APPLICATION NO.	P22/S3152/S73
APPLICATION TYPE	SECTION 73
REGISTERED	31.8.2022
PARISH	ROTHERFIELD PEPPARD
WARD MEMBERS	Jo Robb & James Norman
APPLICANT	Newgate (Sonning) Ltd
SITE	Greylands, Gravel Hill, Peppard Common, RG9 5HD
PROPOSAL	s73 application to vary condition 2 (approved plans) on application ref. P20/S3876/FUL (Demolition of existing house and erection of 6 houses)
	<ol style="list-style-type: none"> 1. Additional windows to all plots; 2. Alterations to roof profile of Plots 1 & 2; 3. Alterations to first floor rear windows of Plots 1 & 2; 4. Alterations to footprint of Plot 1; 5. Alterations to ridge heights of all plots; and 6. Installation of solar PV panels to roof slopes of all plots. <p>(position of Plot 1 altered to reflect surveyed distances to boundary, ridge heights of all plots altered to reflect surveyed heights, solar PV panels added to all plots, overlays of approved and proposed footprint and elevations of Plot 1 and details of hard and soft landscaping including boundary wall treatment provided, as shown on amended plans received 6th July 2023).</p>

OFFICER	Paul Lucas

1.0 INTRODUCTION AND PROPOSAL

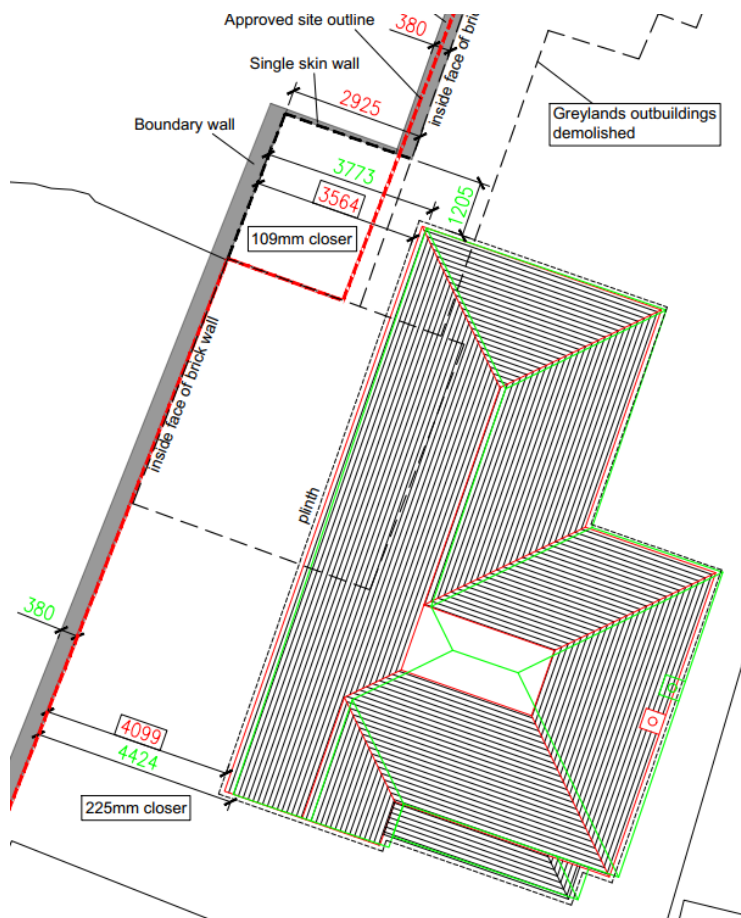
6.10 The ridge lines are set back about 11 to 14 metres from the public highway along Shiplake Bottom. There is a minimum 8 metre separation between the side wall of Plot 1 and No.12 and 5.75 metres between the side wall of Plot 6 and No.2. Under these circumstances, in officers' opinion, the dwellings as built do not appear unduly prominent or intrusive in the street scene along Shiplake Bottom. The dwellings would provide active frontages and introduce further variety to the varied forms and design of dwellings along Shiplake Bottom. Although much of the frontage would be taken up by hardsurfacing to provide access and parking, the application is accompanied by a detailed landscaping scheme, that includes tree (with tree pit details), hedge, and shrub planting around the frontages to help soften the visual impact of the built form. This frontage planting is the same as the scheme submitted under discharge of condition application [P22/S3017/DIS](#), which met with the approval of the council's Tree Officer and could be secured through a planning condition requiring implementation prior to occupation.

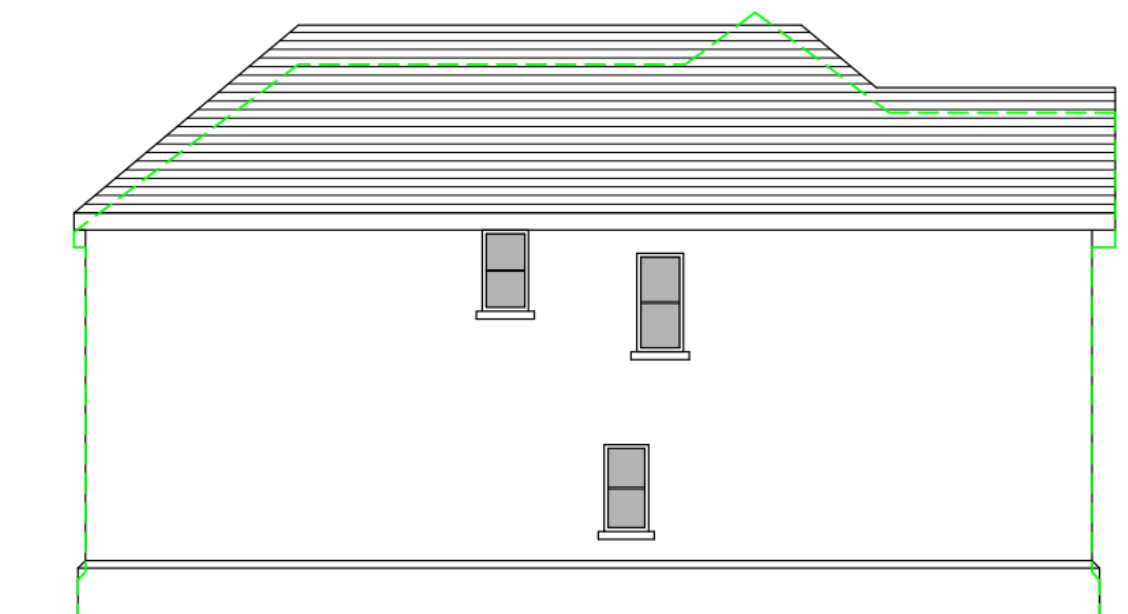
6.11 The visual impact of the dwellings from Gravel Hill would be less due to the higher level of the highway and the greater separation to the rear of the dwellings. The boundary would also comprise a solid wall or fencing, with no vehicular or pedestrian access and the landscaping scheme allows for the planting of seven trees and a continuous hedge on the inside of the boundary. The tree planting would provide mitigation for the loss of tree cover that existed prior to the development taking place, albeit that the previous trees had no statutory protection. The introduction of solar panels onto the side roof slopes would have no significant visual impact, given that such features could be installed under householder permitted development rights.
